Introduction

TV

VOLUME 2

Fig. 63 — Industrial

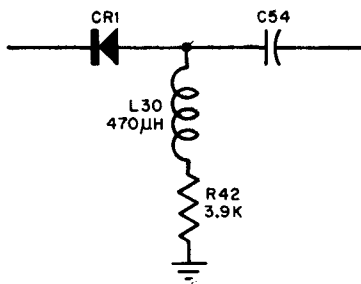
INDUSTRIAL Chassis IT-35R
Improvement in video response
 (see Fig. 63).

Fig. 65 — Jackson

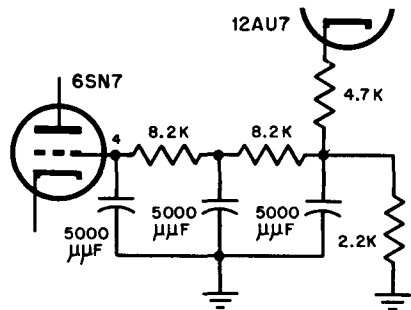
1. Remove vertical-integrator plate.
2. Make up vertical integrating circuit as shown in the the figure.
